State of New Mexico
 Energy, Minerals and Natural Resources

Form C-103
 Revised July 18, 2013

SUNDRY NOTICES AND REPORTS ON WELLS (DO NOT USE THIS FORM FOR PROPOSALS TO DRILL OR TO DEEPEN OR PLUG BACK TO A DIFFERENT RESERVOIR. USE "APPLICATION FOR PERMIT" (FORM C-101) FOR SUCH PROPOSALS.)	
1. Type of Well: Oil Well <input type="checkbox"/> Gas Well <input checked="" type="checkbox"/> Other SWD	
2. Name of Operator Key Energy Services LLC.	
3. Address of Operator 1500 Citywest Blvd., Suite 800, Houston, TX 77042	
4. Well Location Unit Letter H : 2310 feet from the North line and 860 feet from the East line Section 13 Township T-23 south Range 27 east NMPM Eddy County	
11. Elevation (Show whether DR, RKB, RT, GR, etc.)

**Key Energy
BKE Well #1**

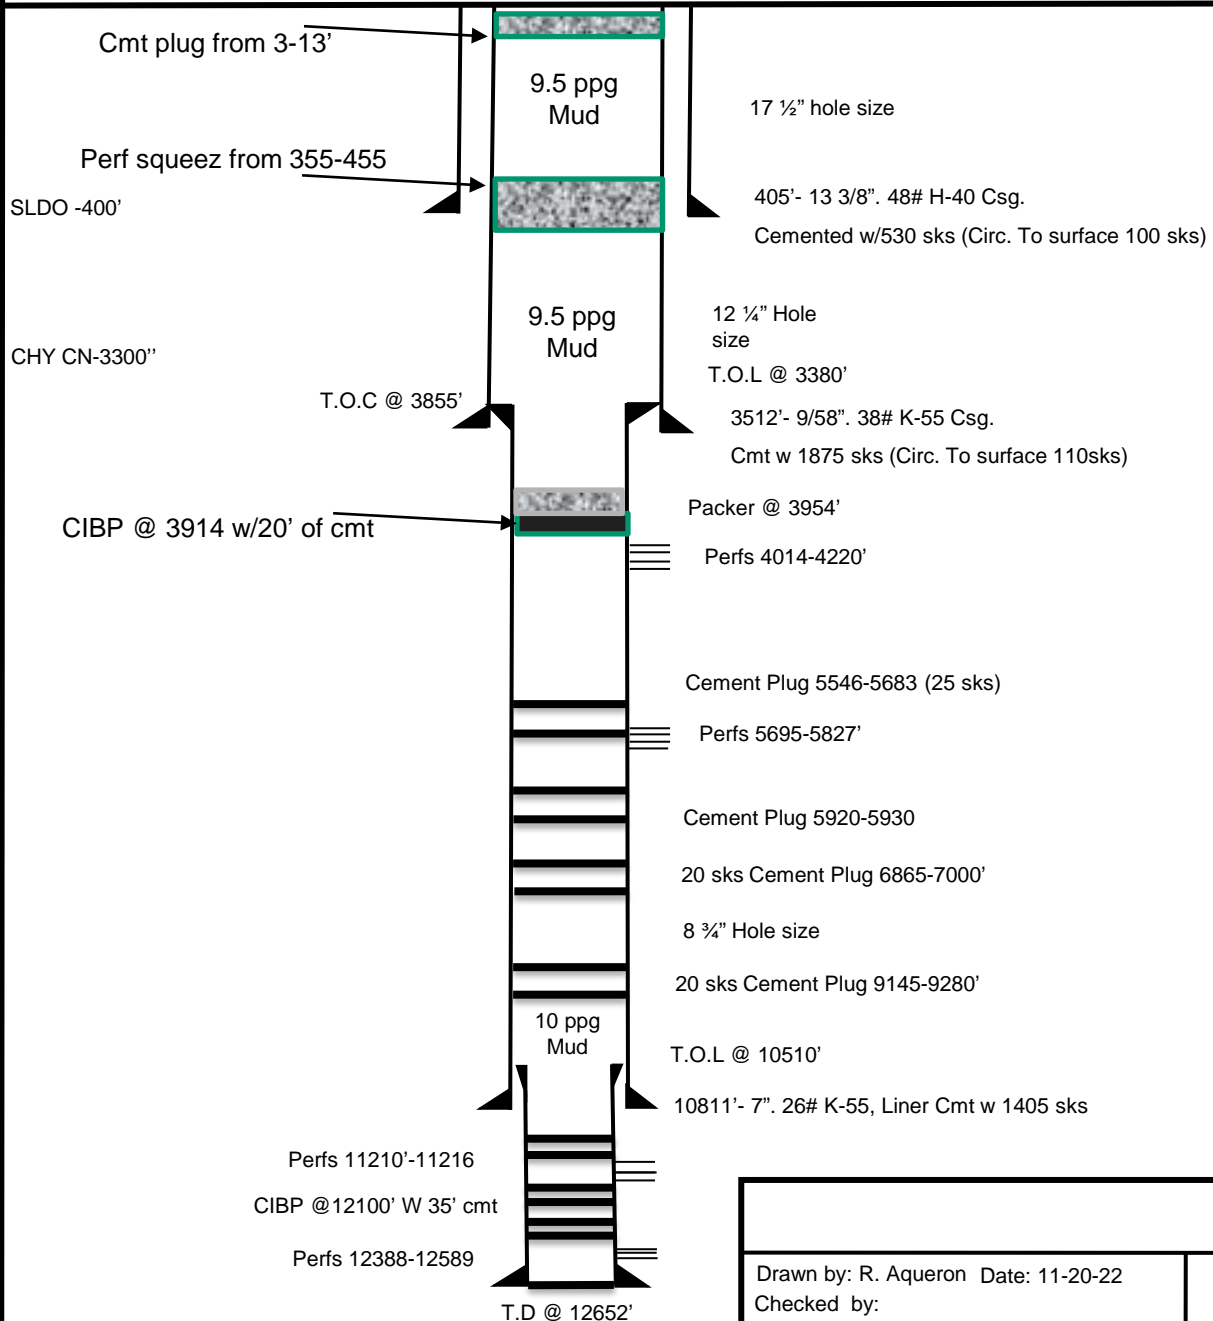
P&A of Brine well. Will kill well with 13# mud, pull tbg & set CIBP @ 3960' w/ 4" (4sxs) of cmt on top. Will perf and squeez 100 sxs @ 85'. Will set a plug from 12-3'(10sxs). 9.5# mud will fill the hole in between all cmt plugs set. Well should be monitored for 5 years, to ensure there is no leakage of the P&A. The work will be completed depending on rig availability.

1. CIBP @ 3960' - test csg 500psi/30min - run CBL to surface

2. Spot 150 sx cmt 3960' - WOC & tag at 3250' - CIBP, TOC, TOL, T Cherry Canyon

3. Perf @ 450' & attempt to circ cmt to surf. If no circ spot 35 sx cmt 500' - 400'

4. Perf @ 250' & attempt to circ cmt to surf. If no circ - cement to surf

****SEE ATTACHED COA's****

MUST BE PLUGGED BY 11/30/2023
